Re: Town of Davie – Federal Aviation Administration ("FAA") – Comments to Final Environmental Impact Statement (FEIS) for the Development and Extension of Runway 9R/27L and Other Associated Airport Projects at Fort Lauderdale/Hollywood International Airport (FLL)

The undersigned represent the Town of Davie ("Town" or "Davie") regarding the Final Environmental Impact Statement dated June 2008 ("FEIS") for Development and Extension of Runway 9R/27L and the Associated Airport Projects at Fort Lauderdale/Hollywood International Airport ("Airport" or "FLL"). The Town is disappointed that the FEIS has for the most part, failed to correct the deficiencies identified in the Town's prior comments to the Draft Environmental Impact Statement ("DEIS"). The comments include the Town's May 21, 2007 Comments ("Town May 21, 2007 Comments) and the Town's February 29, 2008 Comments ("Town February 29, 2008 Comments). The Town May 21, 2007 Comments and Town February 29, 2008 Comments are incorporated by reference. Further, the FEIS has failed to address the substantive comments provided by other municipalities and interested persons. To the extent these comments are not inconsistent with the Town's

Exhibit "A"

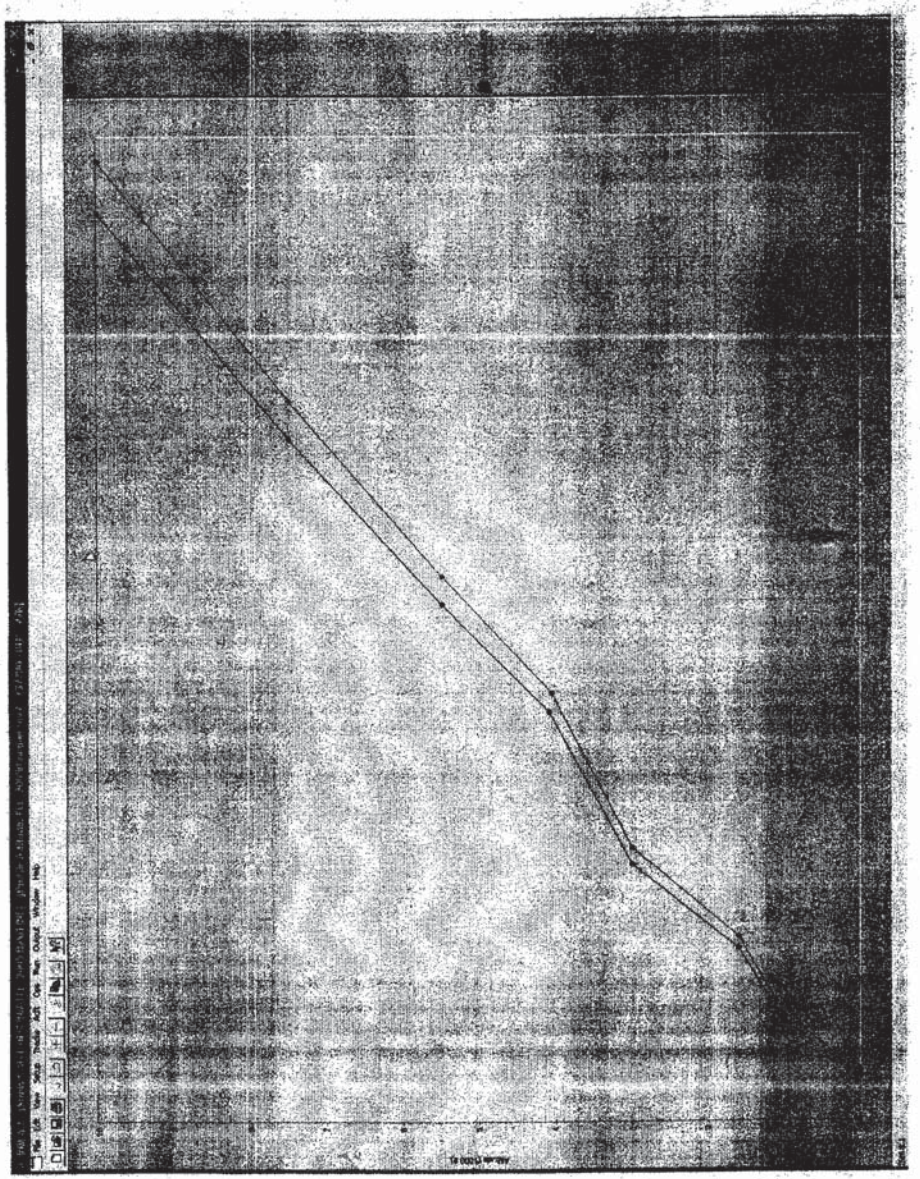
b. The standard integrated noise model ("INM") vertical departure profiles used in the FEIS effectively depict aircraft flying at higher altitudes than the actual aircraft flying over the Town of Davie. With the planes depicted as flying at a higher altitudes, the noise impact on the Town is underestimated and, therefore, the noise analysis is flawed. 8.11

c. We have attached Exhibits A and B to highlight this error. Exhibit A shows graphs of altitude versus distance for the INM standard departure profile from the FEIS INM input files for the most common aircraft at FLL (i.e., Boeing 737 700). The graph shows that, at a distance of 18,219 feet (i.e., three nautical miles) from the start of takeoff roll the aircraft is at an elevation of 3,000 feet. Exhibit B provides plots of the altitude of west-bound departures for two time periods: June 2007 and January 2008. As can be seen in these radar plots, aircraft typically achieve an altitude of 3,000 feet approximately 36,456 feet (i.e., six nautical miles) from the start of takeoff roll. The actual planes departing FLL are therefore climbing at lower rates than the planes modeled in the INM study.

Exhibit "B"

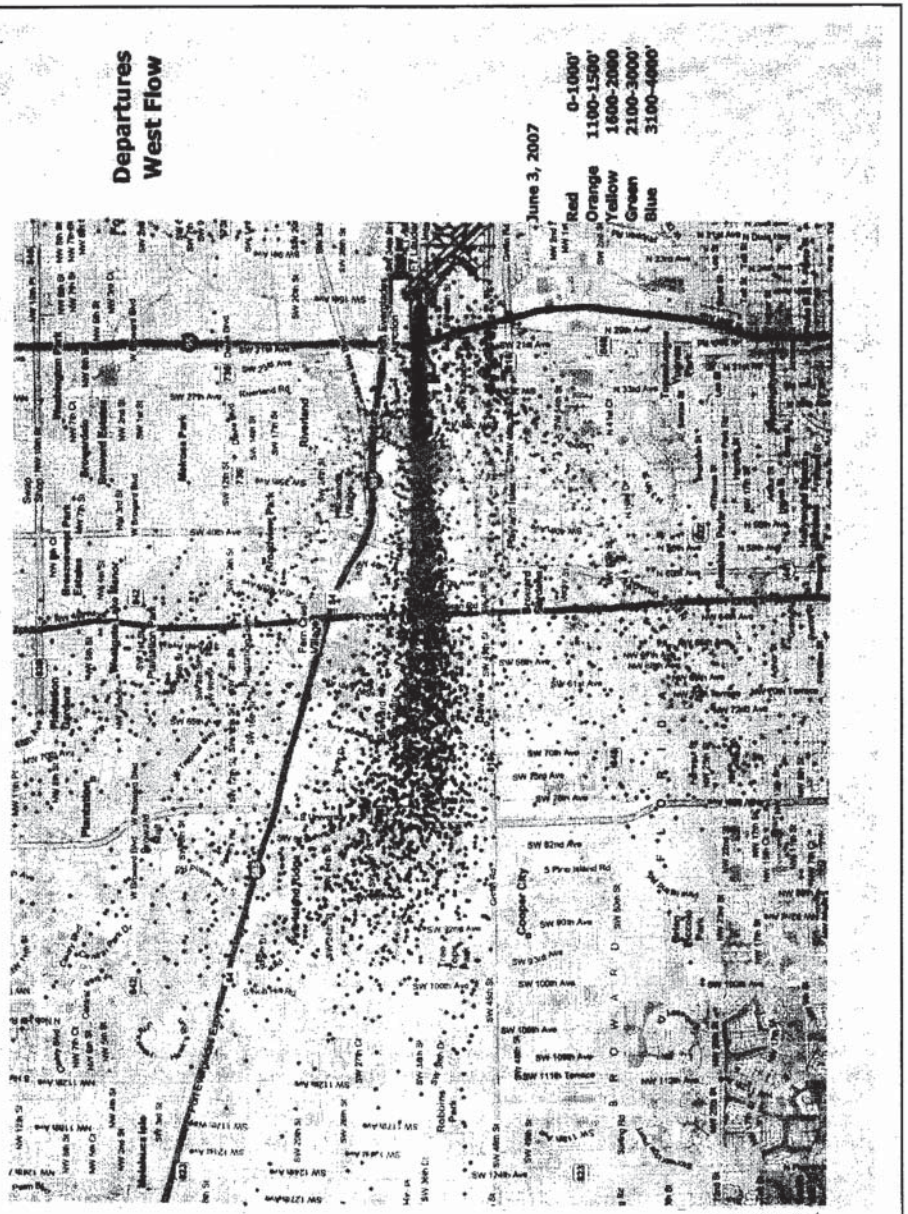
d. To illustrate this point further, Exhibit C plots the INM standard departure profile for a 737-700 with a stage length of one (this is the same data as shown in Exhibit A) and compares this departure profile to the departure profile extrapolated from the radar data included in Exhibit B.
